ADDENDUM NO. 1

September 14, 2026

**Perry Meridian High School Phase 2 Renovations
401 W. Meridian School Road
Indianapolis, IN 46217**

9 ENLARGED TEACHER DEMONSTRATION
SCALE: 1/2" = 1'-0" REF. 1 / A101A

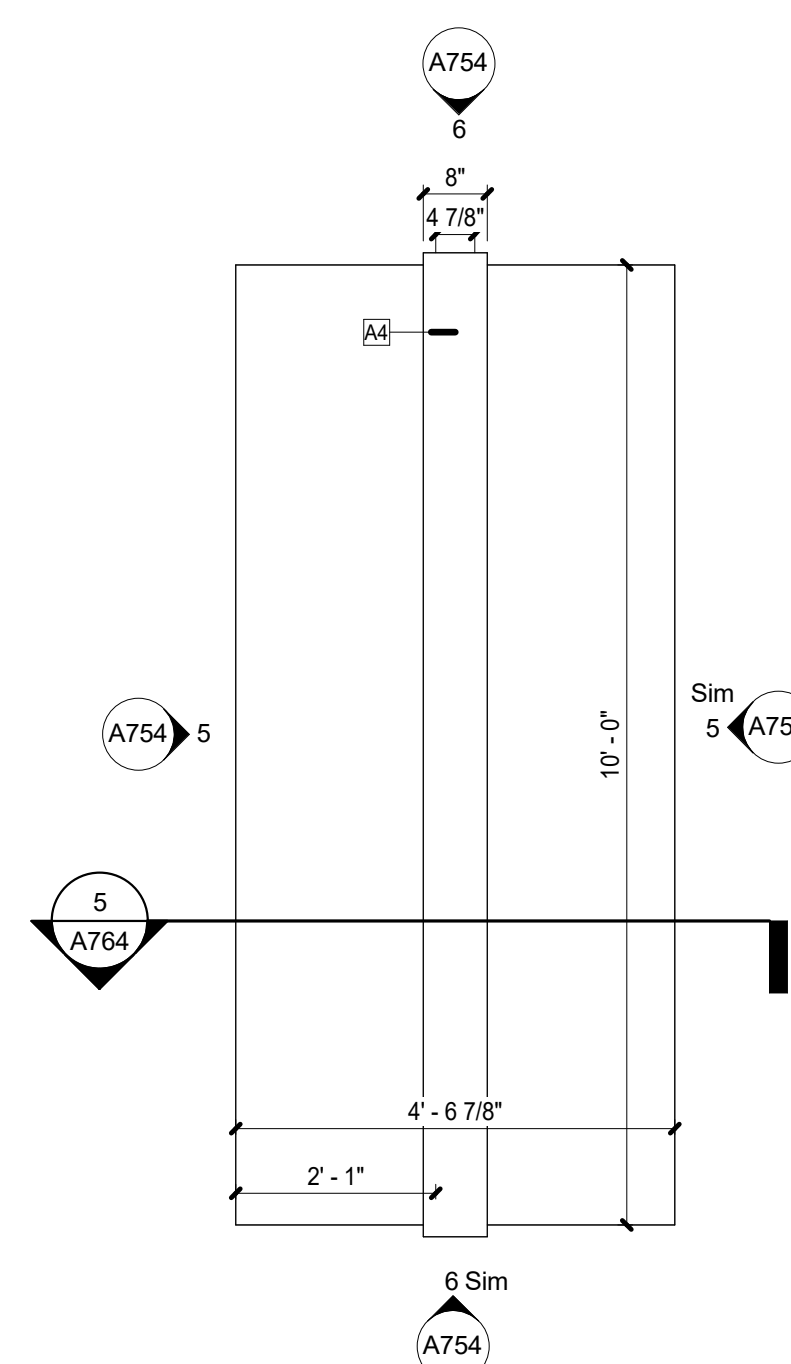
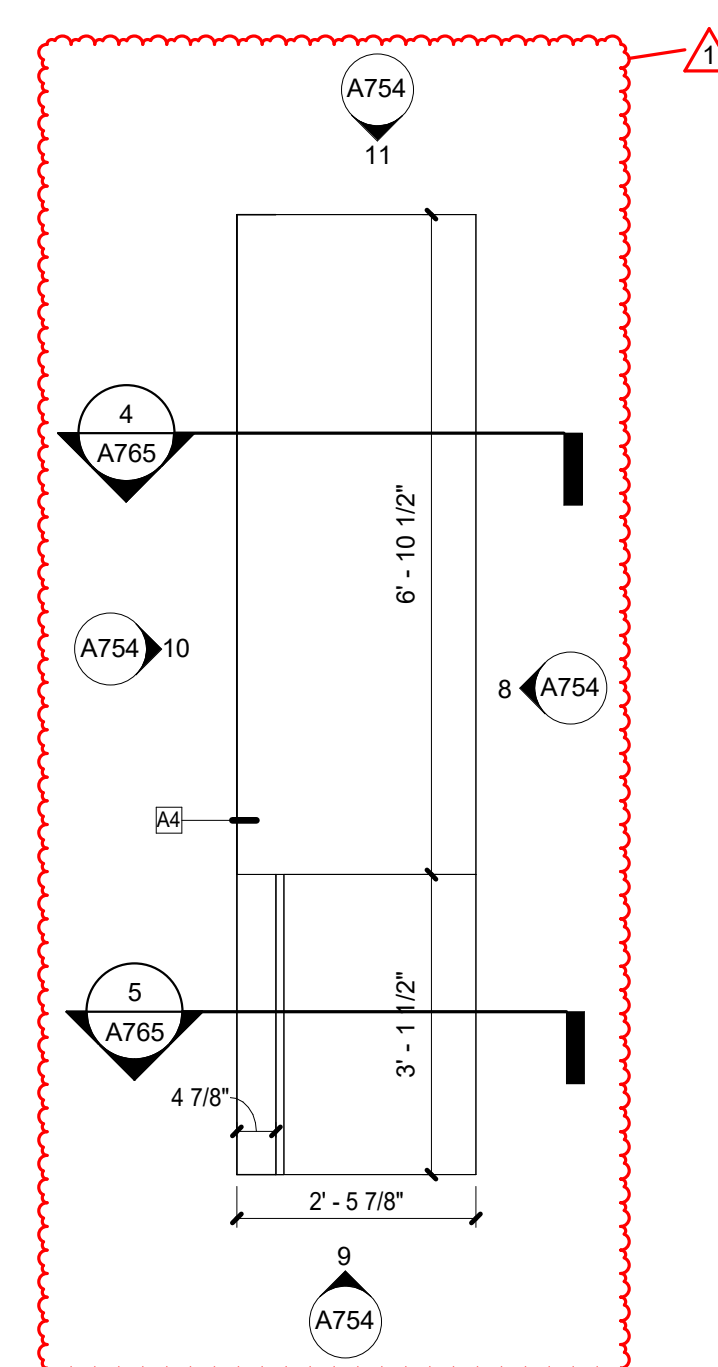
- Added enlarged plan callout for teacher demo station in Food Lab 12K

- Added casework elevations, notations, and dimensions to enlarged plan 9/A731.

5 CSWK - FOOD LAB TEACHER 2
SCALE: 1 1/2" = 1'-0" REF. 9 / A731

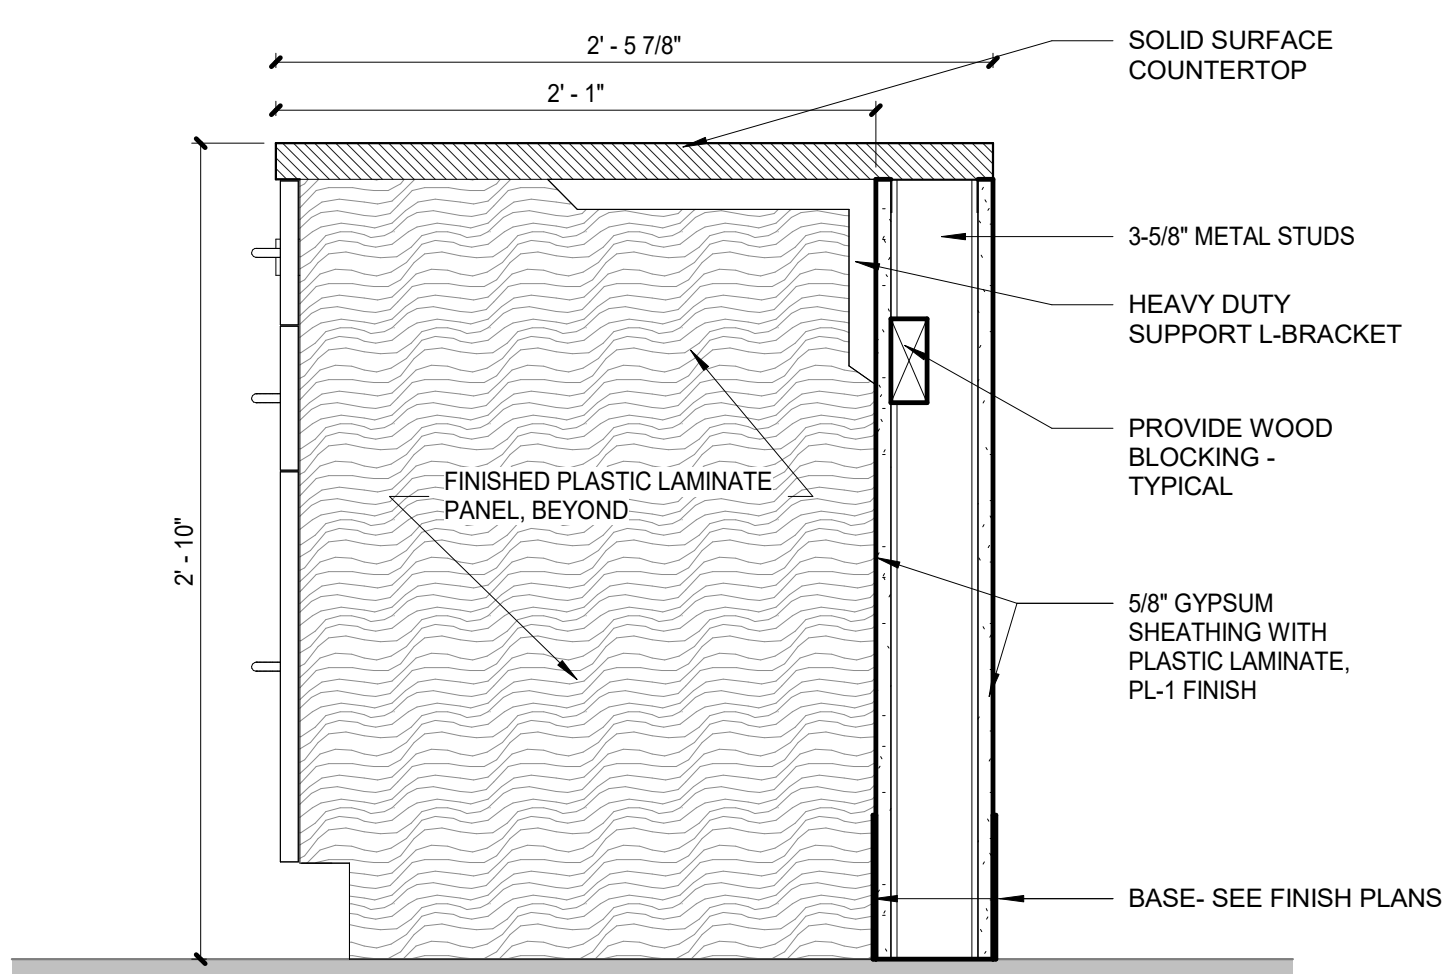
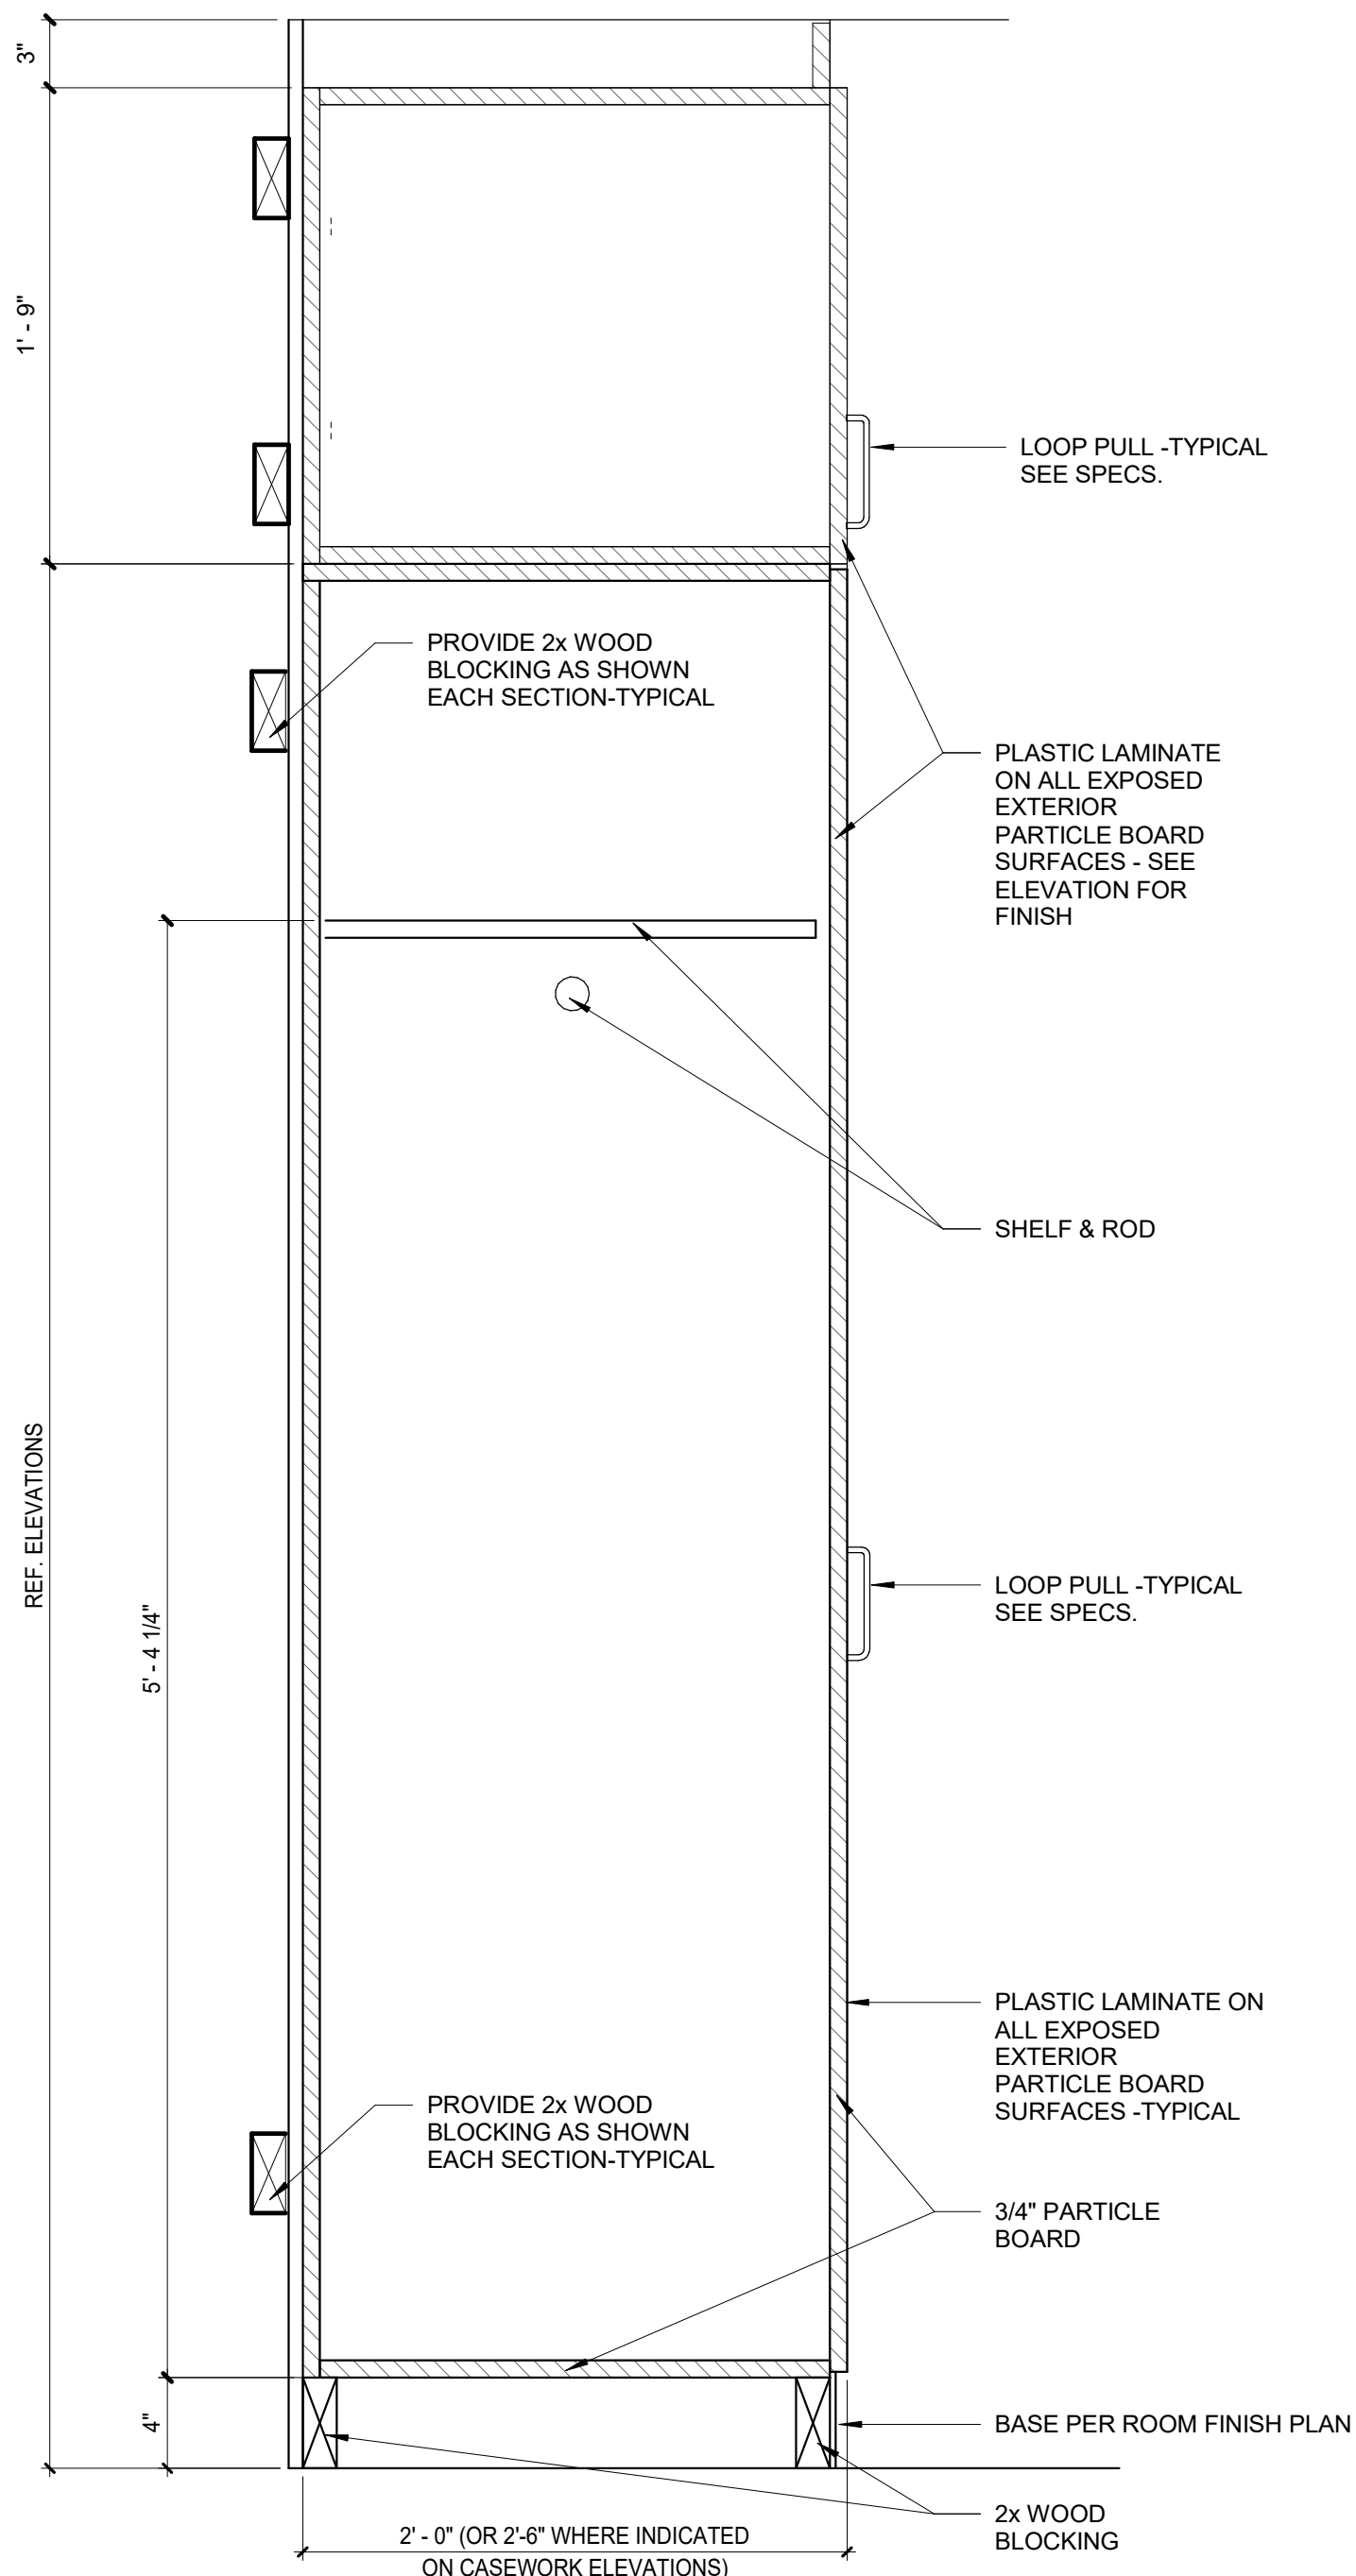
- Added casework sections 4/A765 and 5/A765.

MD108

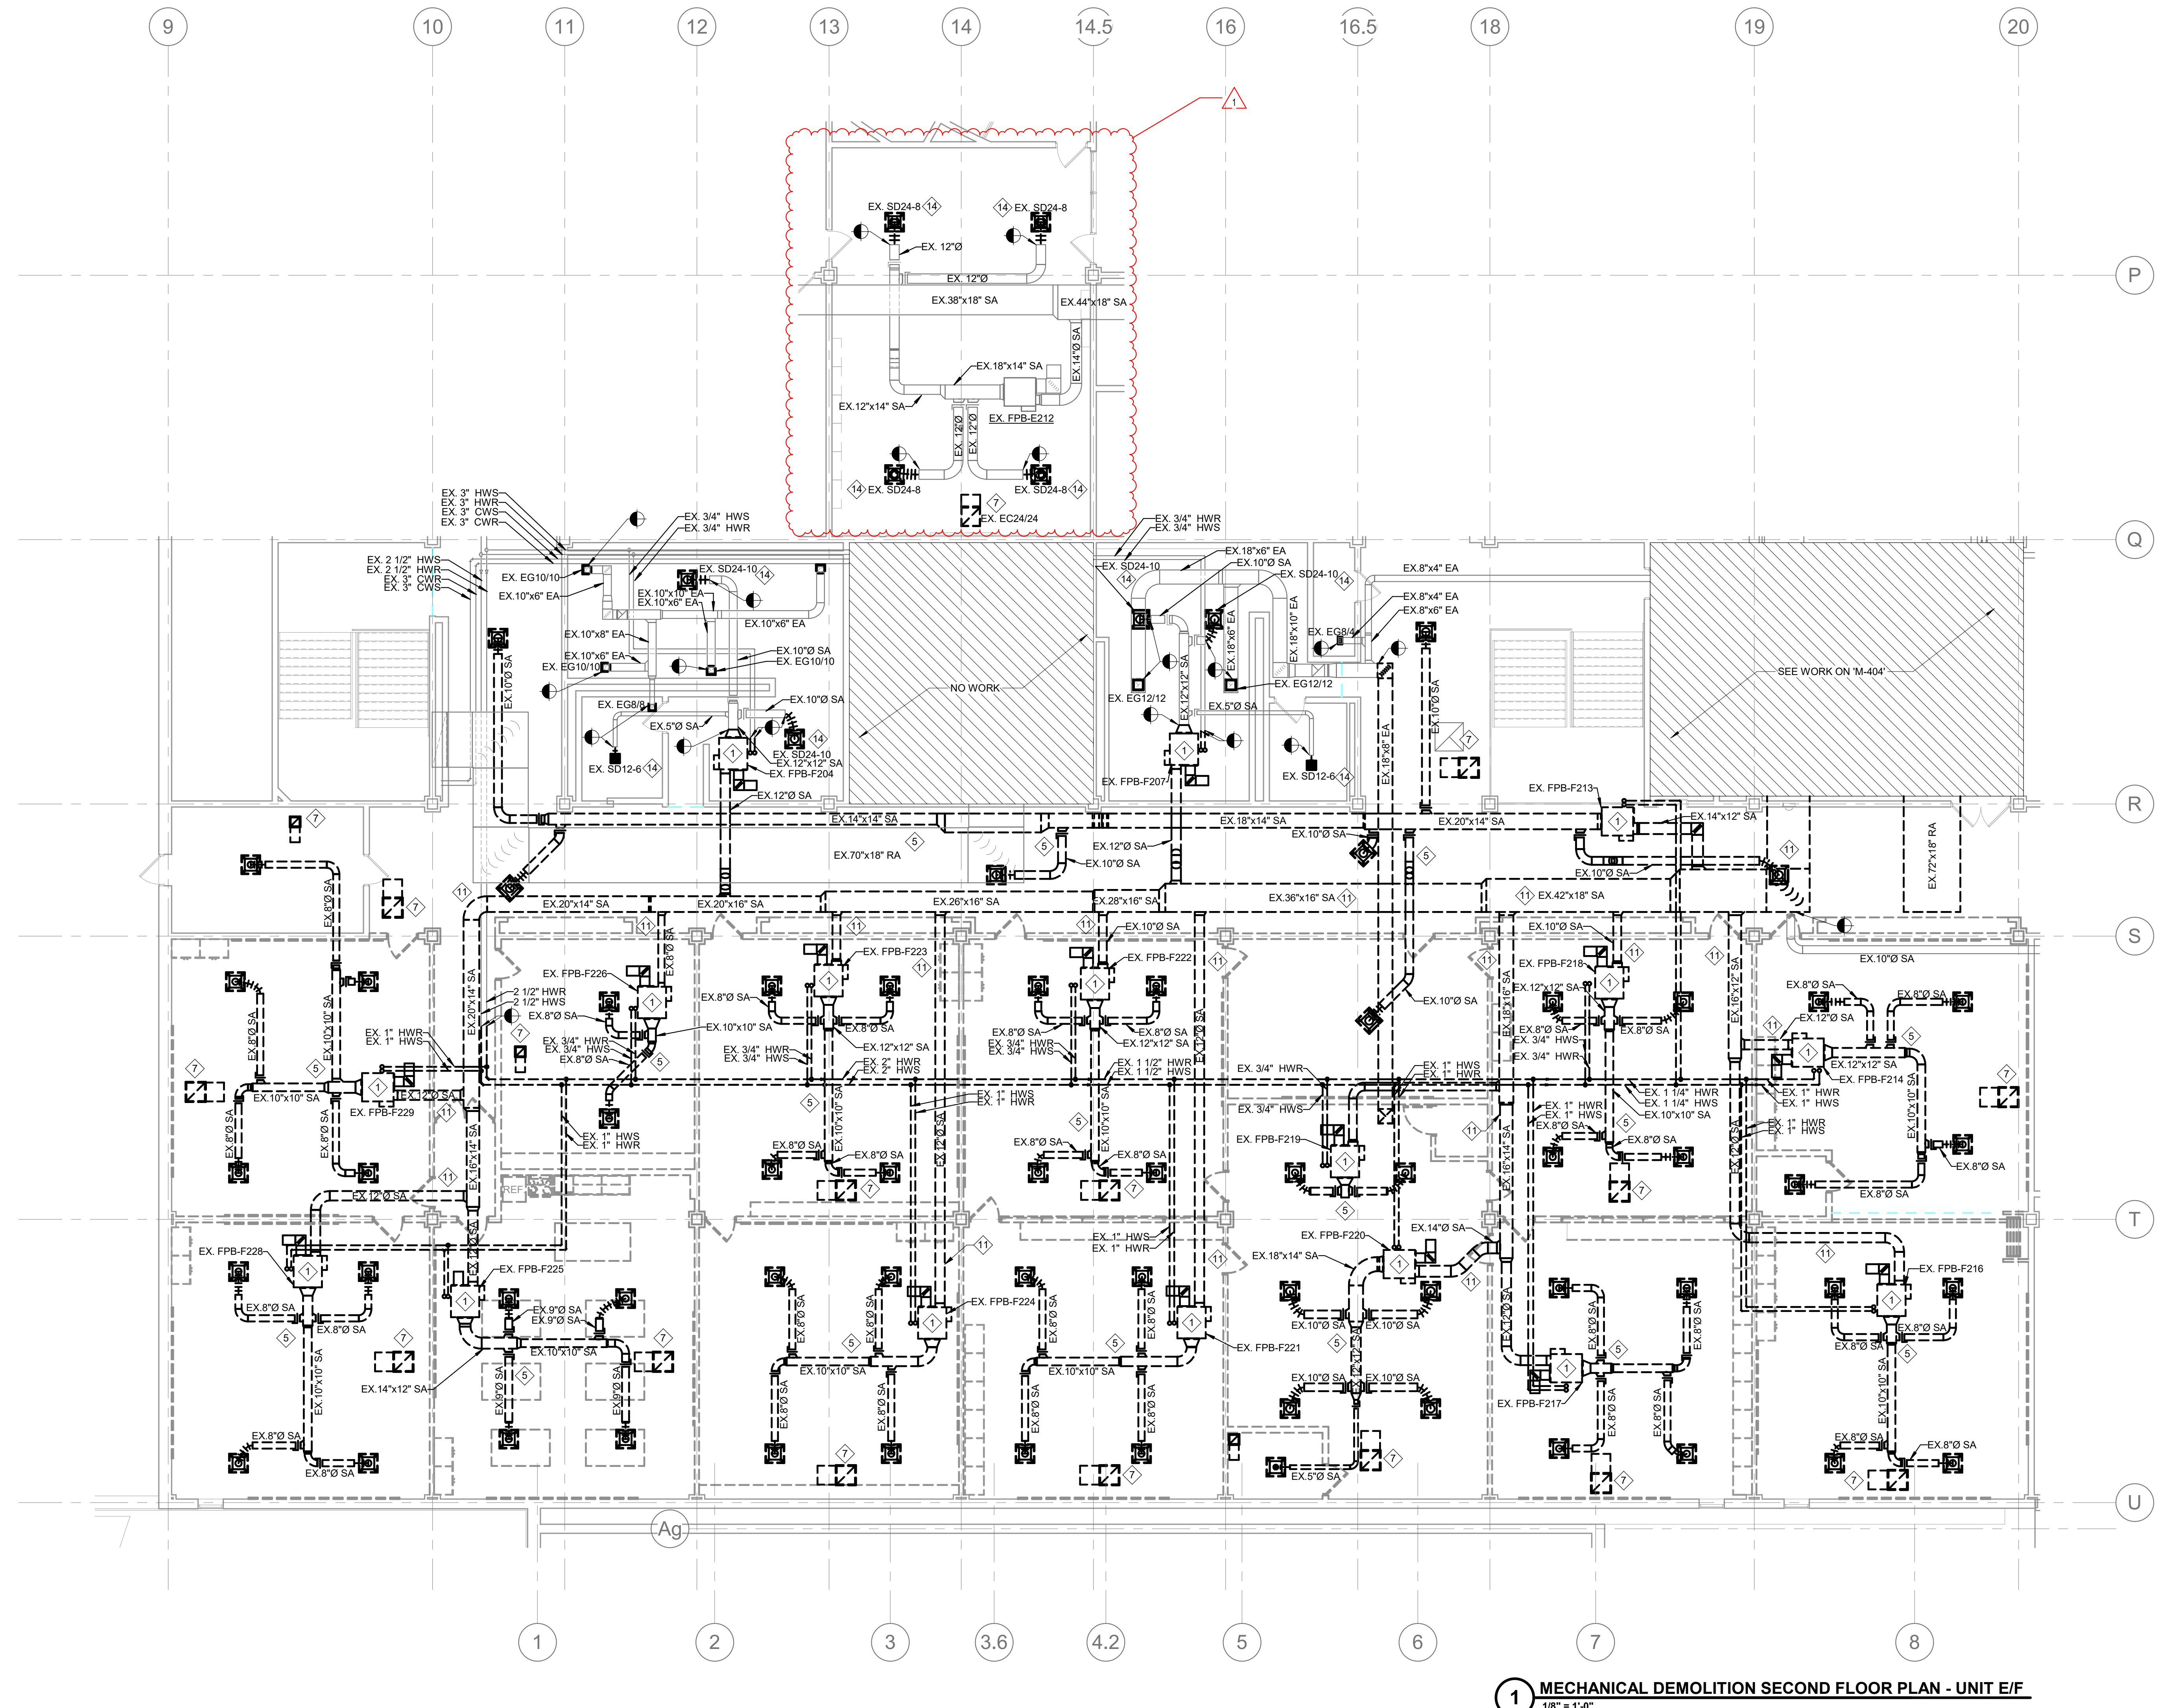
Change: Revise sheet to include scope of work to remove existing ceiling supply diffusers and grilles in BUSINESS 2-8C.

1. Revise sheet to include scope of work to remove existing ceiling supply diffusers and grilles in BUSINESS 2-8C.
